MEMORANDUM

To:	Airport Land Use Commission (ALUC)
From:	Fionna Jensen, ALUC staff, June 18, 2024 (831) 796-6407
Meeting Date:	July 1, 2024
Subject:	Scheduled Item 7a – County of Monterey (York School) Proposed improvements to York School’s athletic field, including installation of hybrid turf, ball netting, an all-weather track, and an upgraded drainage system (24CP00599).

Staff recommends the Monterey County Airport Land Use Commission (ALUC) find the proposed York School athletic field improvements (HCD File No. 24CP00599) consistent with the 2019 Airport Land Use Compatibility Plan for the Monterey Regional Airport (ALUCP).

Figure 1. ALUCP Exhibit 4B and 4C (Long Range Noise Exposure Contours and Airport Safety Zones). The subject property and proposed project site (athletic field) are outlined in red dashed lines.

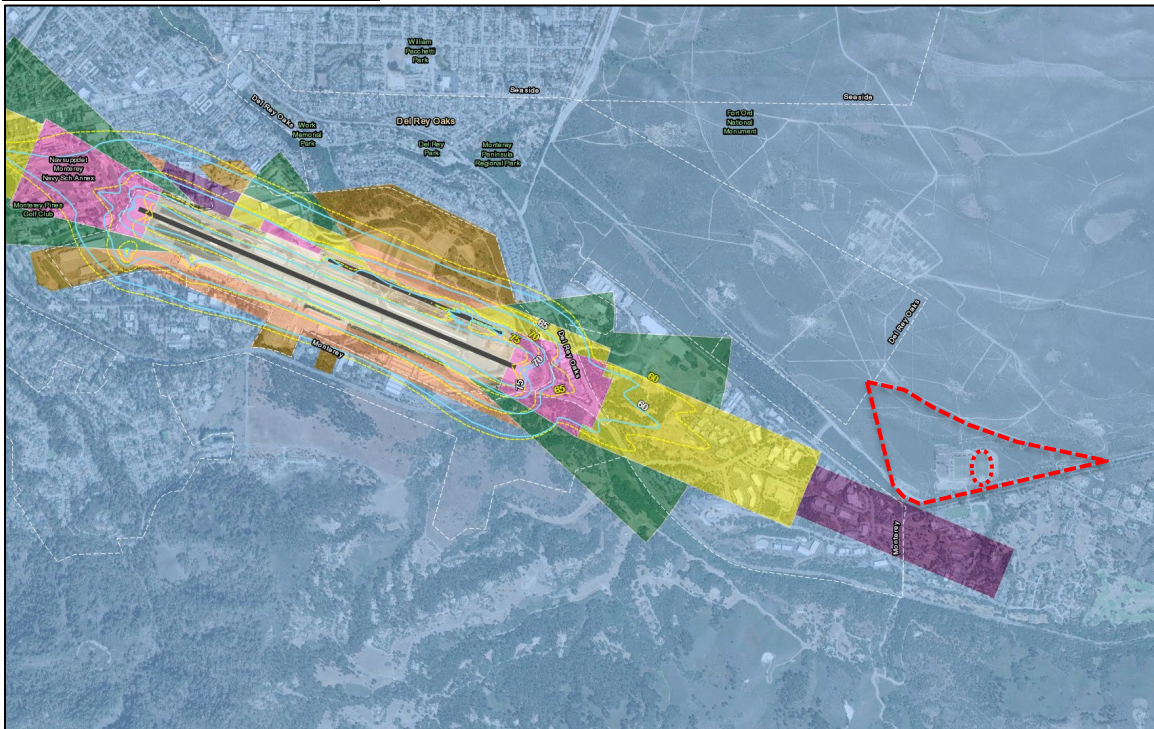
The subject property is located approximately 8,760 feet east of Monterey Regional Airport Runway 28L. The subject property is located within Safety Zone 7, which allows for all uses except hazards to flight, outdoor stadiums, and other similar high-intensity uses. The existing field has three single-bench portable bleachers; these will be retained and re-used. No additional seating is proposed. Safety Zones 2 through 5 prohibit schools, while the establishment of a school could be a compatible use within Safety Zone 7. The existing and proposed replacement athletic field is an accessory to York School and will not be used by the public at large and therefore will continue to have an overall low and limited intensity. Thus, as an athletic facility used solely by York School, staff does not consider the existing or proposed athletic field and associated site improvements to be an “outdoor stadium.” Based on this determination, the existing and proposed replacement athletic facility is allowed with a compatible intensity within Safety Zone 7.

York School was established at the subject property in 1963, prior to the adoption of the 1987 Monterey Regional Airport Comprehensive Land Use Plan (CLUP) and the 2019 Airport Land Use Compatibility Plan. In the 1987 CLUP, York School is identified as an “Incompatible Use Outside 65 CNEL.” Adoption of the 2019 ALUCP did not remove existing incompatible uses. York School is located within Safety Zone 4 (Outer Approach/Departure Zone), which prohibits children’s schools. Accordingly, the school remains an incompatible use but is also recognized as a non-conforming use that existed prior to the adoption of either the 1987 CLUP or 2019 ALUCP. Since the athletic field is accessory to a non-conforming use (York School), the following discussion addresses consistency with ALUCP Policy 4.1.4.1 (Modifications to Nonconforming Uses), which states:

Figure 2. ALUCP Exhibit 4E (Part 77 Terrain). The subject property is outlined in a red line.

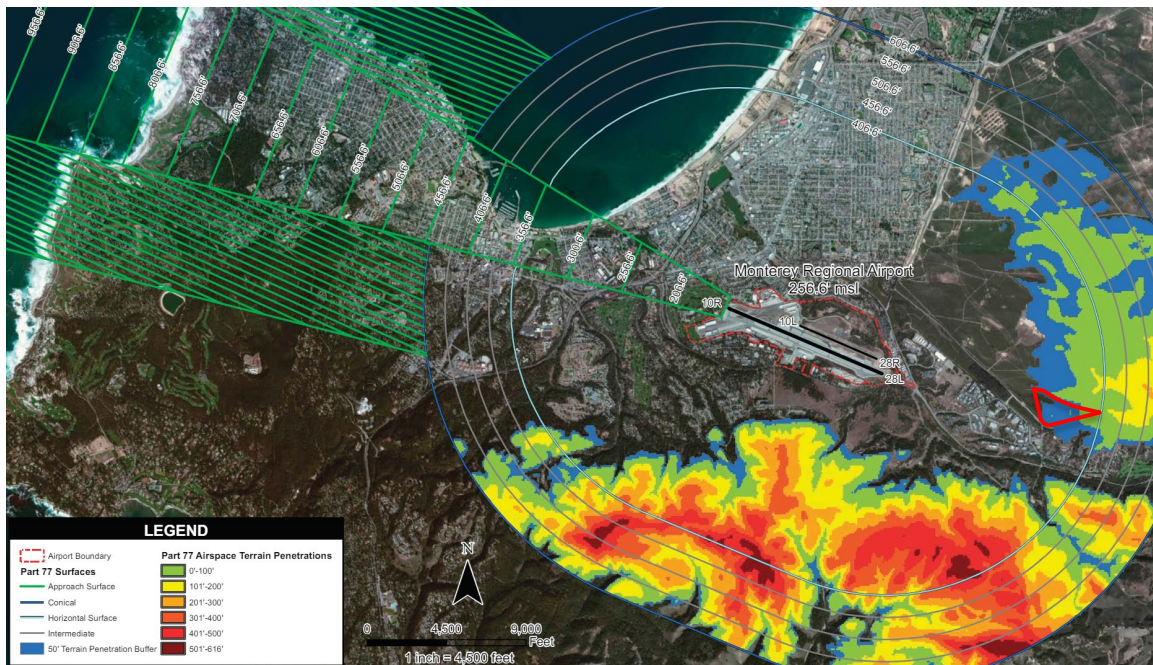
As shown in the above figure, a majority of the subject property is within the “50-foot Terrain Penetration Buffer” which means that the property has elevations that are within 50 feet of 406 feet. Although the eastern portion of the subject property has elevations in excess of 406 feet AMSL (green areas shown in Figure 2), the existing athletic field has elevations ranging between approximately 401 and 404 feet AMSL. The replacement hybrid turf, all-weather turf, and drainage improvements will maintain their existing elevations (below 406 feet AMSL). However, the top of the proposed ball nets (netting to stop stray balls from being kicked, hit, or thrown off the field) encroach into Part 77 surfaces by 15 feet. The 20-foot-tall ball nets will have top elevations of approximately 421 feet above AMSL. Policy 4.2.3.2(e) of the ALUCP prohibits new structures on terrain that already penetrates Part 77 surfaces. All development is proposed on terrain that is below Part 77 surfaces (406 feet AMSL).

The ALUCP (Policy 4.2.3.2) requires that projects that penetrate or have the potential to penetrate Part 77 surfaces obtain a ‘Determination of No Hazard to Air Navigation’ from the Federal Aviation Administration. This determination, which can take between 45 days and 3 months to obtain, is required to be submitted with the ALUC application materials. In this case, York School has received a ‘Determination of No Hazard to Air Navigation’ from the FAA for a future development proposal that contemplates lighting being installed around the athletic field (**Attachment C**). The FAA’s determination concluded that “the proposed structures [future lighting proposal] would penetrate the MRY Horizontal surface; however, it would not conflict with airspace required to conduct normal VFR [visual flight rules] traffic pattern operations” (**Attachment C**). It is important to note that

Figure 3. Heights of future lighting proposal (pink) vs. proposed ball netting (orange).

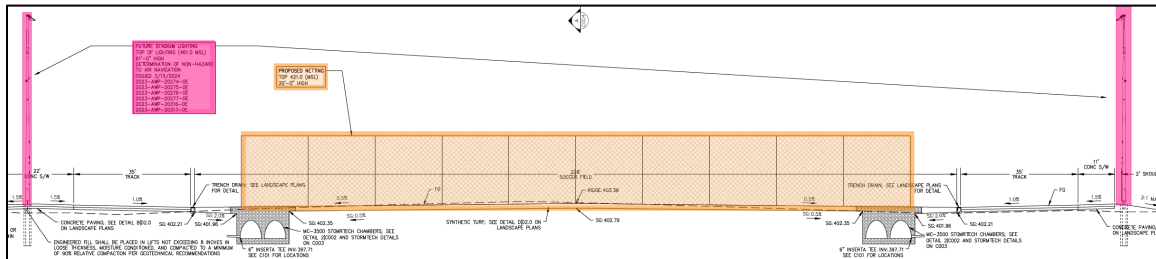
The future lighting proposal has a top height of 461 feet AMSL and would be located in close proximity to the proposed ball nets (located at the north and south ends of the replacement athletic field), which will have a top height of 421 feet AMSL (see **Attachment D** and Figure 3). The future lighting proposal's height exceeds Part 77 surfaces by 55 feet while the proposed ball net height exceeds Part 77 surfaces by 15 feet. York School has requested that the requirement to obtain the FAA Hazard Determination be waived because the future lighting proposal is taller than the proposed ball nets and has received a 'Determination of No Hazard'. However, due to the clear language of Policy 4.2.3.2, staff has applied a condition of approval (ALUC-9) that requires the 'Determination of No Hazard' to be obtained and submitted to ALUC staff prior to installation of the ball nets. This approach would allow York School to replace the turf field with hybrid turf, modernize the dirt track with an all-weather track, and upgrade the drainage systems while it obtains the FAA Hazard Determination. If a Determination of No Hazard is obtained, York School can install the ball nets.

FUTURE STADIUM LIGHTING DETERMINATION OF NON-HAZARD TO AIR NAVIGATION
 ISSUED 3/15/2024
 2023-AWP-20274-OE
 2023-AWP-20275-OE
 2023-AWP-20276-OE
 2023-AWP-20277-OE
 2023-AWP-20316-OE
 2023-AWP-20317-OE

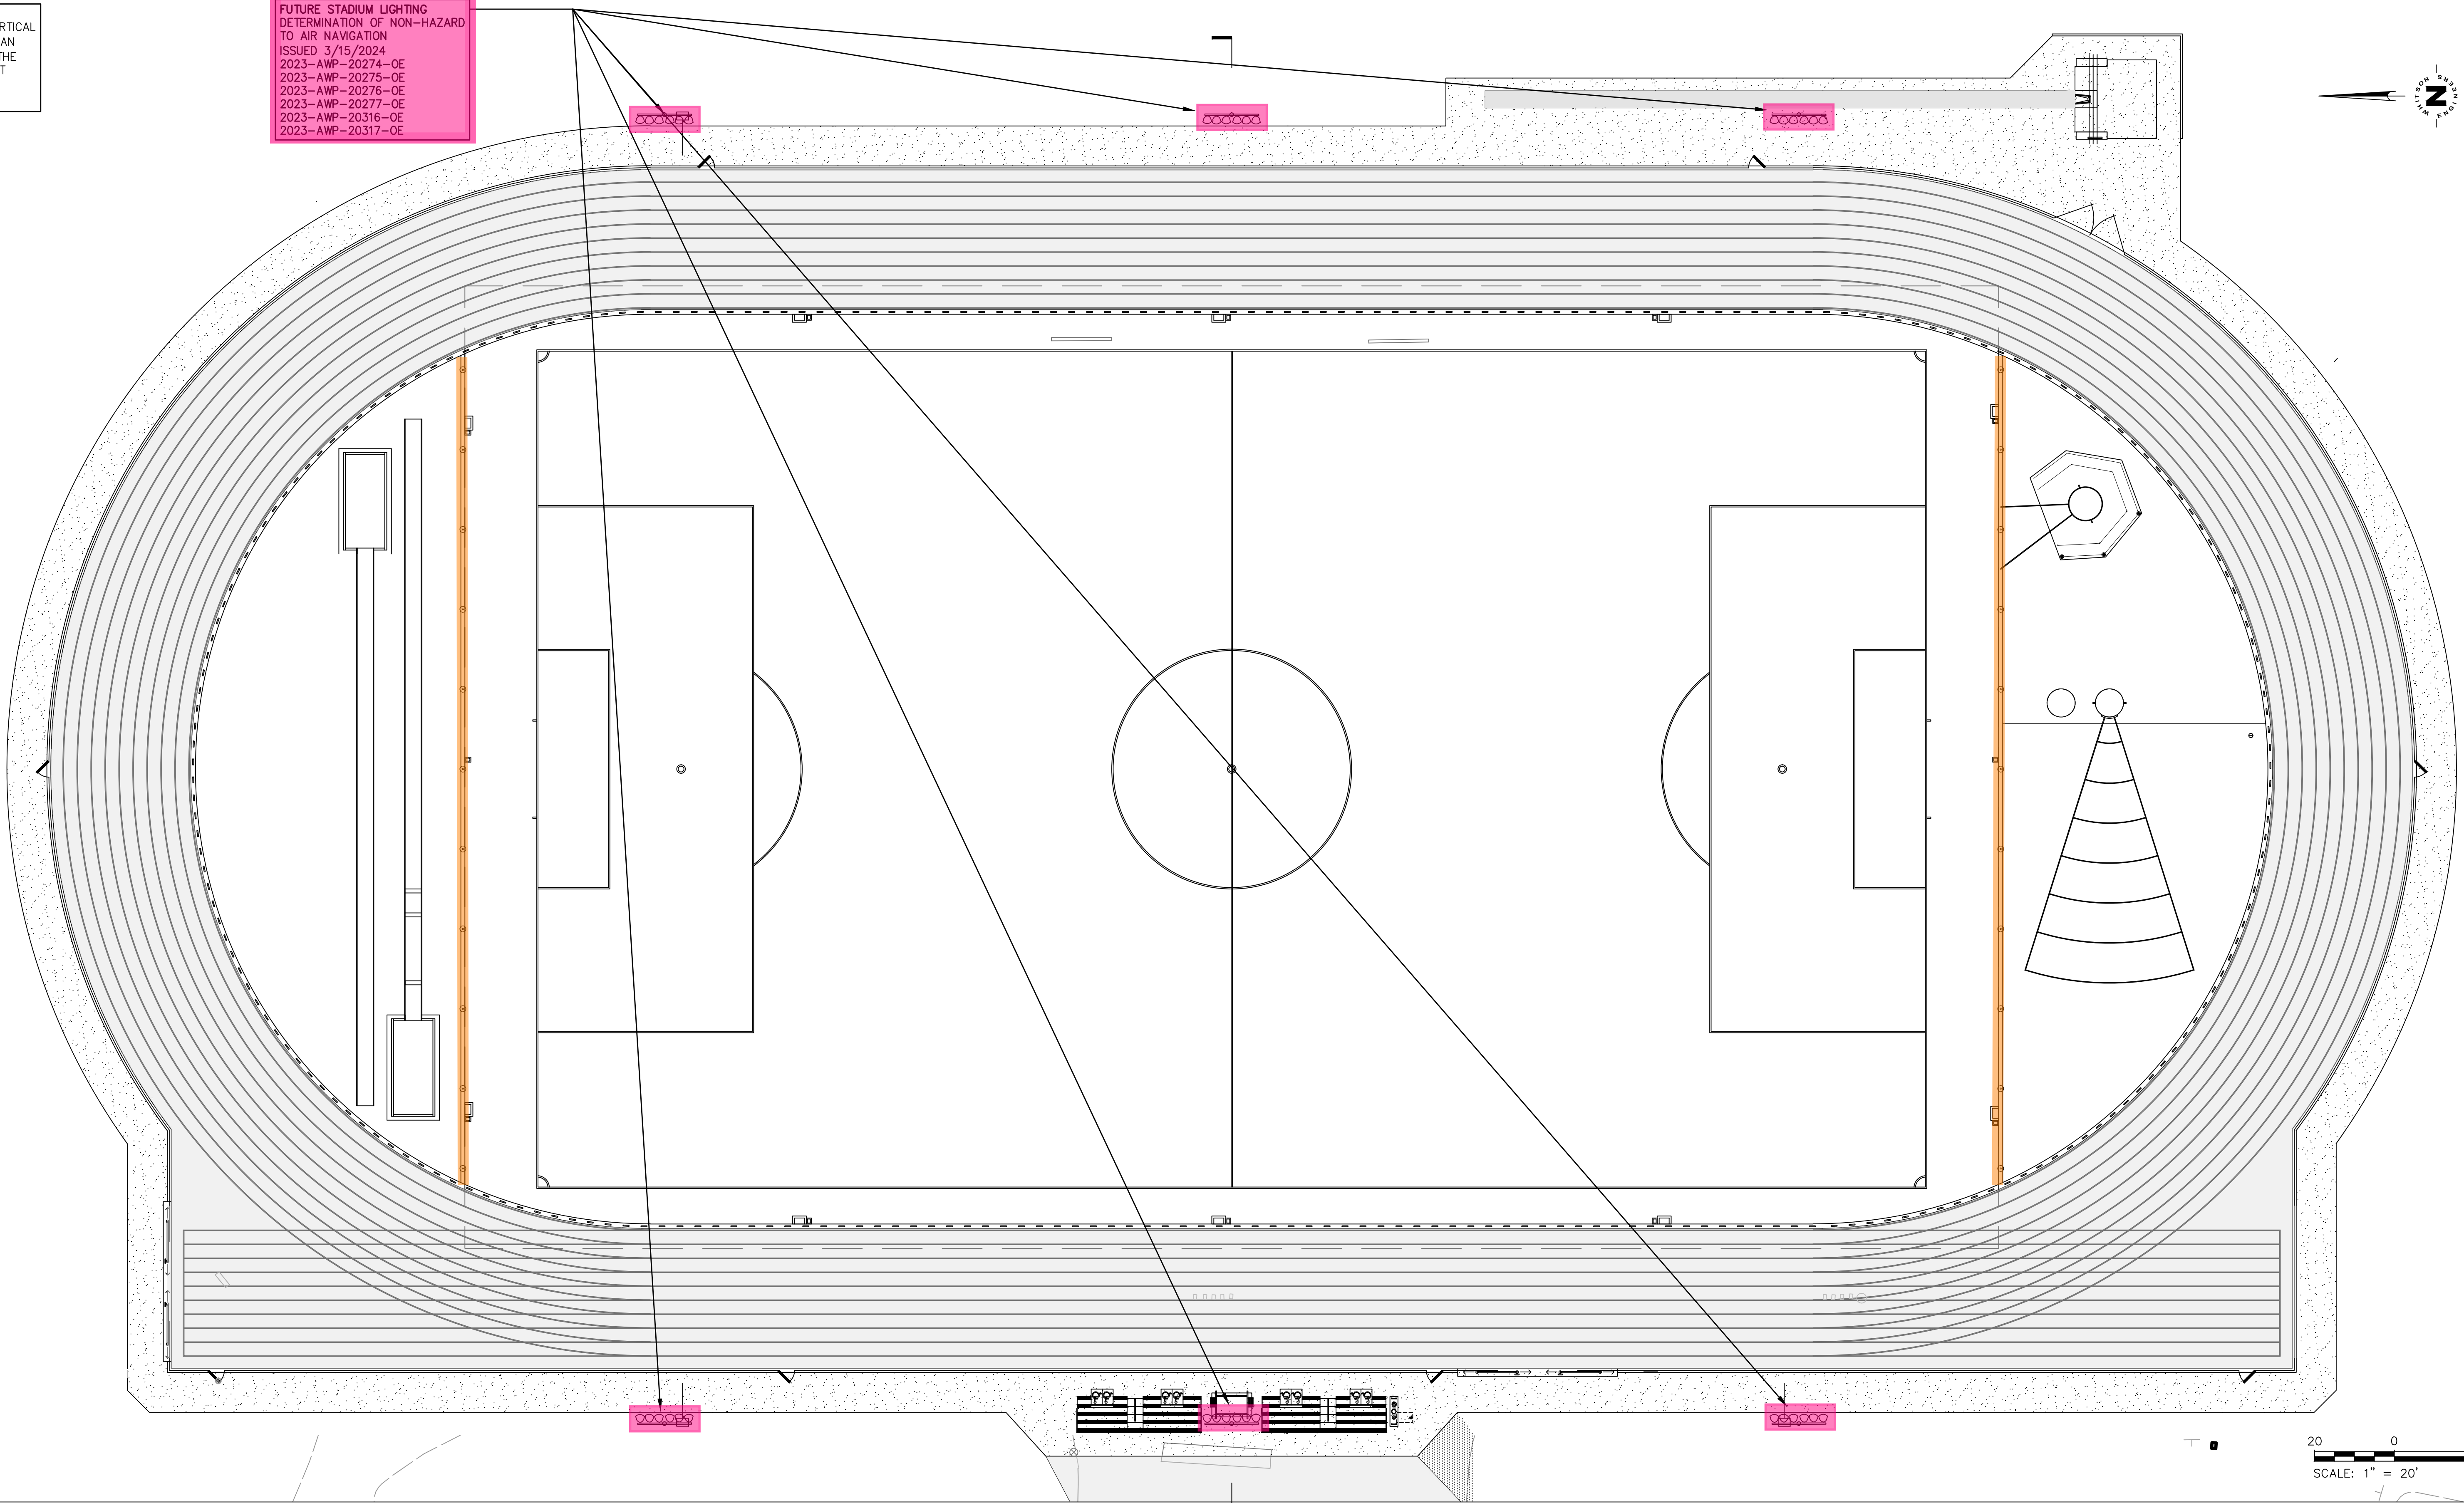
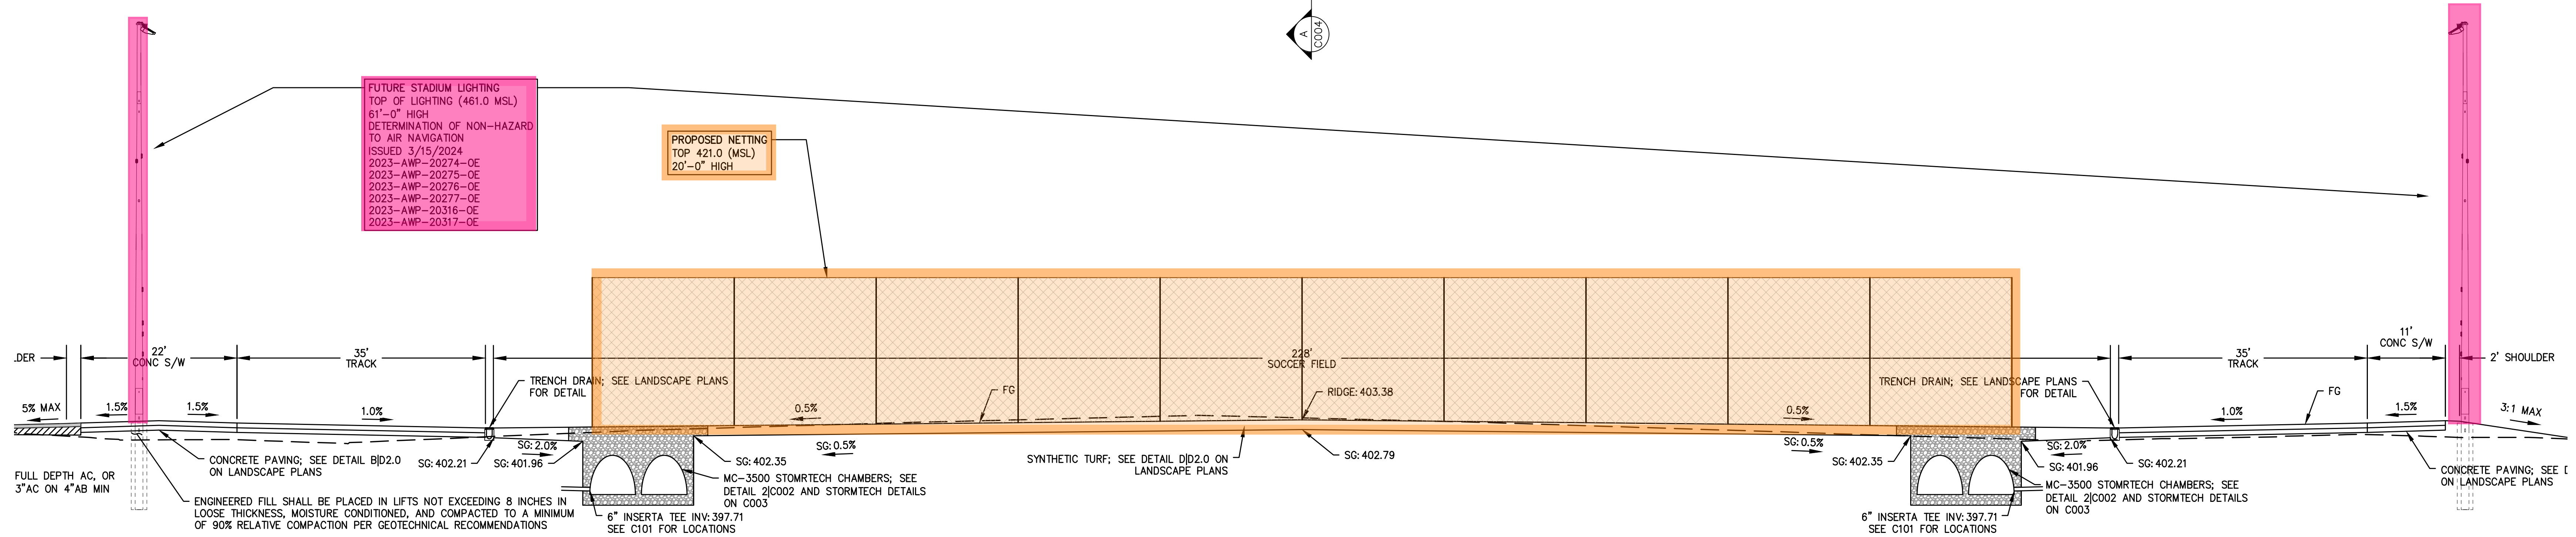
Part 77 obstruction standards are used to screen the many proposals submitted in order to identify those that warrant further aeronautical study. Further study is conducted in order to determine if the proposal would have a significant adverse effect on protected aeronautical operations and airspace. Accordingly, the fact that a proposed structure exceeds an obstruction standard of Part 77 does not provide a basis for determination that the structure would constitute a hazard to air navigation. An objection solely based on penetrating Part 77 surfaces without substantiating any aeronautical effect or quantifying such effect is not considered to be a valid objection.

It is determined that the proposed structures would not have a substantial adverse effect on the safe and efficient use of navigable airspace by aircraft.

determines otherwise. Just because a proposed structure exceeds a Part 77 surface does not automatically make it a hazard. There are no IFR impacts, and the VFR traffic pattern airspace is not impacted. Further study did not indicate that the structures would affect a significant number of operations. Marking and lighting was considered but deemed unnecessary.
